R99DE

Blue Bird Body Company has determined that certain Blue Bird All American forward engine buses equipped with Allison World transmissions do not conform to Federal Motor Vehicle Safety Standard No. 102 Section 3.1.3 pertaining to starter interlock requirements. On subject vehicles, the engine starter is operative with transmission selector in forward or reverse positions.

RECALL R99DE
ALL AMERICAN NEUTRAL SAFETY SWITCH NONCOMPLIANCE
MODIFICATION INSTRUCTIONS

FIGURE 1

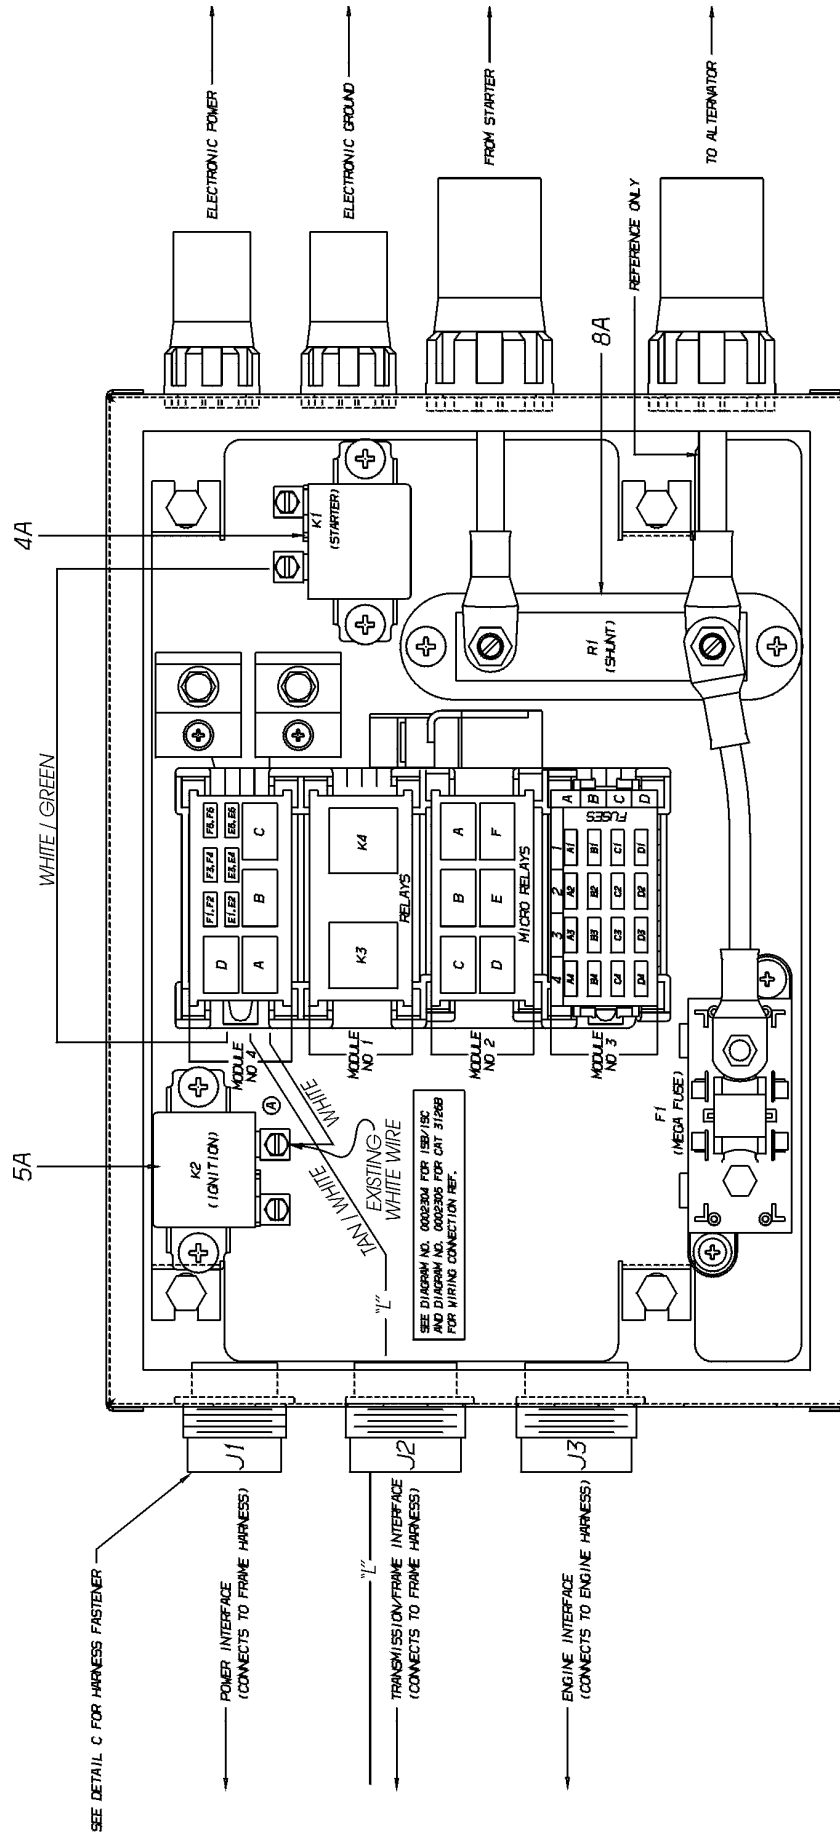
NOTE: Reference Figure 1 on page 3 for component locations.
4. Locate open position for module 4 (relay/fuse block) supplied.
5. Insert supplied relay/fuse block with wires extending out of left hand side of block, be sure all four mounting tabs are locked into place.

6. Remove two-way connector from starter relay located in upper right hand corner of PDU. (Location 4A)
7. Remove white /green wire, #18114, from connector. Remove end terminal and fold wire back against itself and tape.

8. Route green/white wire from new relay/fuse block to starter relay connector and install in location where wire #18114 was removed.
9. Install connector back onto the starter relay. (Location 4A)

10. Remove two-way connector from ignition relay located in upper left hand corner of PDU. (Location 5A)
11. Remove white wire, #1231, from connector and remove terminal.

12. Route white wire from new relay/fuse block to ignition relay.
13. Strip both white wires 3/16" and crimp on single 250 series terminal. (Supplied)
14. Install terminal with two white wires attached back into two-way connector in location where wire #1231 was removed.

15. Install connector back onto the ignition relay. (Location 5A)
16. Remove terminal sealing pins on harness connector plug and PDU receptacle in location "L". (See J2)

17. Insert tan/white wire from relay/fuse block into terminal “L” of female connector inside the PDU.
18. Insert tan/white wire #158 into terminal “L” of male connector on frame harness. (Location J2)
19. Follow harness forward approximately 20” to 12 connector plug. Remove secondary lock from connector and plug from terminal “C”. Insert 150 series pin into terminal location “C” of connector. (Matching connector will have circuit #18123, tan wire in matching location)
20. Install loom over wire and secure with nylon wire ties to existing harness.
21. Check wiring connections.
22. Replace PDU cover.
23. Reconnect battery ground cables.
24. Check ignition operation according to the chart below.
